UNITED STATES PATENT AND TRADEMARK OFFICE

10/760,075

Office Action Summary	Application No. 10/760,075	Applicant(s) FORTIN ET AL.	
	Examiner Nicholas Woodall	Art Unit 3733

DETAILED ACTION

Figure 1

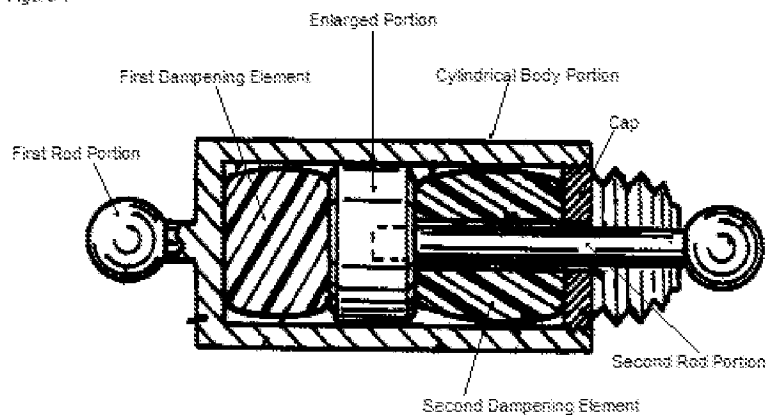
Regarding claim 13, Navas discloses a device comprising a cylindrical body portion, a first rod portion, a second rod portion, a first dampening member, and a second dampening member (see Figure 1 below). The cylindrical body includes a first end and a second end. The first rod portion extends from the first end of the cylindrical body in a first direction. The second rod portion includes a first elongated body and an enlarged end portion, wherein the enlarged end portion is positioned within the cylindrical body portion and the first elongate body extends in a second direction opposite the first direction and passes through an opening in the second end of the cylindrical portion. The first dampening member is positioned between the enlarged end portion and the first end of the cylindrical body. The second dampening member is

positioned between the enlarged end portion and the second end of the cylindrical body. Regarding claim 14, Navas discloses a device wherein the second end of the cylindrical body comprises a cap. Regarding claim 15, Navas discloses a device wherein the cap includes a threaded inner region. Regarding claim 17, Navas discloses a device wherein the second dampening member includes a ring shape with an opening capable of receiving the first elongated body of the second rod portion. Regarding claim 18, Navas discloses a device wherein the opening in the second end of the cylindrical body portion includes a width that is less than a width of the enlarged end portion but is greater than a width of the first elongated body capable of allowing the second rod portion to laterally bend with respect to the cylindrical body portion.

Regarding claim 13, Navas discloses the invention as claimed except for the first dampening element and the second dampening element each include at least one inclined face. Clayton Jr. teaches a device comprising a first dampening element and a second dampening element, wherein each of the dampening elements includes at least one inclined face in order to help transfer heat from the device caused by friction (column 4 lines 30-59). It would have been obvious to one having ordinary skill in the art at the time the invention was made to manufacture the device of Navas wherein each of the dampening elements include at least one inclined face in view of Clayton Jr. in order to help transfer heat from the device caused by friction.
